**Re: Draft Anchor QEA Building Assessment Summary Report
Vo-Toys Site, Harrison, NJ**

Comments on Anchor QEA's Building Assessment Summary Report Vo Toys Site, Harrison, NJ

March 22, 2019

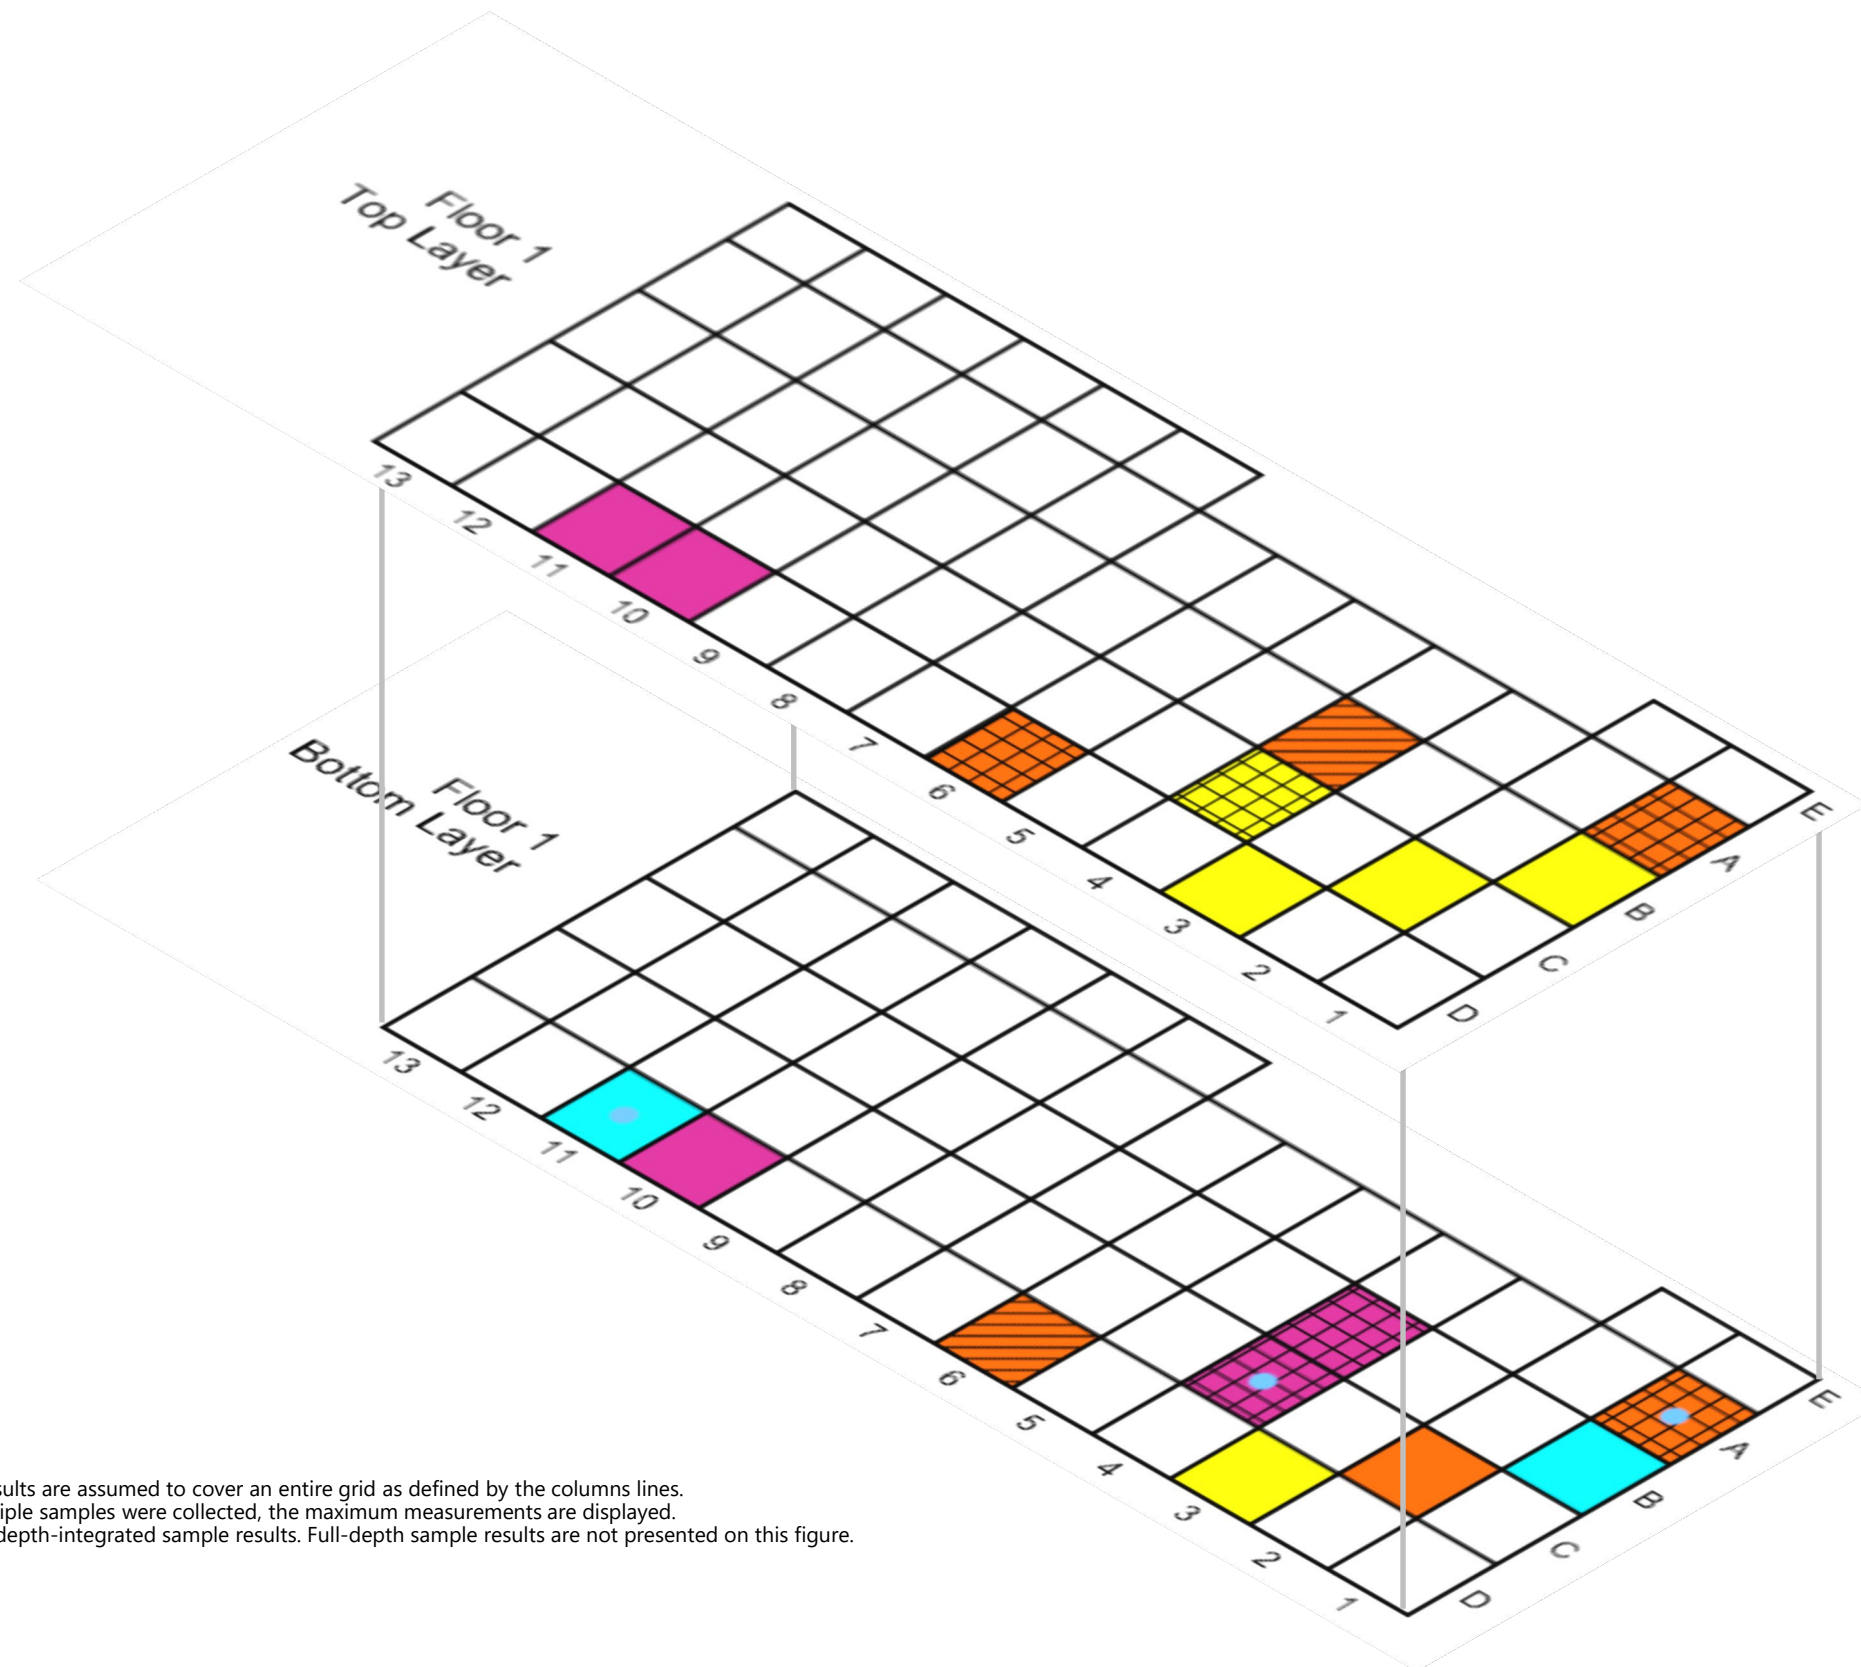
- Pools and globules of elemental mercury are present in multiple locations in Buildings B and C. Elemental mercury was also confirmed to have fully penetrated the floor slab on the first floor in Building B (see attached, Figure 4-10 of the BASR) – information that is consistent with the widespread presence of elemental mercury that had previously been documented on the first floor of Building B (*e.g.* underneath sections of wood sub-flooring and within floor excavations);

- High concentrations of mercury were found in the first floor building floor materials (concrete, tar paper, cinder) in all three buildings (*e.g.*, see attached, Figure 4-10 of the BASR);
